# Car Stereo Service Bulletin

**CSA-14**

**Model:** XR-C210, XR-C410

**Subject:** Intermittent Audio Muting

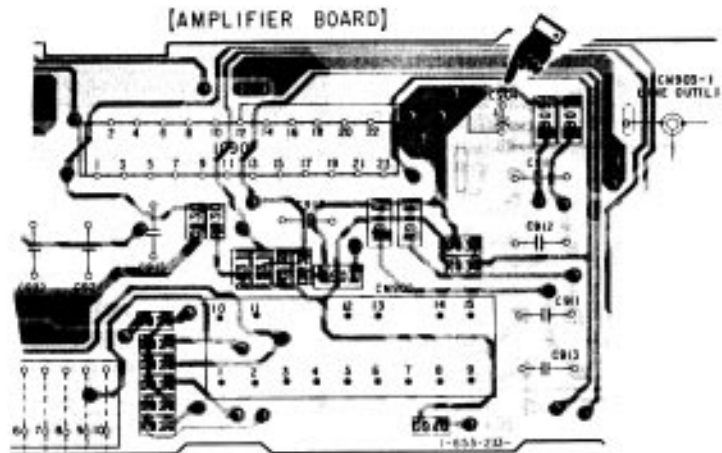
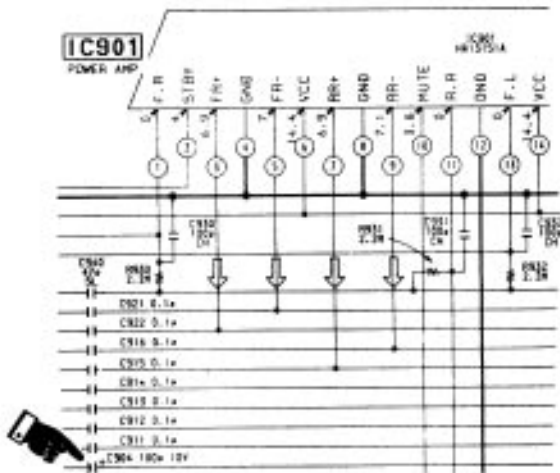
The audio may intermittently mute at high volume levels.

If the customer complains of this problem, change the value of C904 on the AMPLIFIER board as shown below.

REF	FORMER		NEW	
	DESCRIPTION	PART NUMBER	DESCRIPTION	PART NUMBER
C904	CAPACITOR, ELECT., 100UF, 10V	1-124-584-00	CAPACITOR, ELECT., 10UF, 16V	1-126-157-11
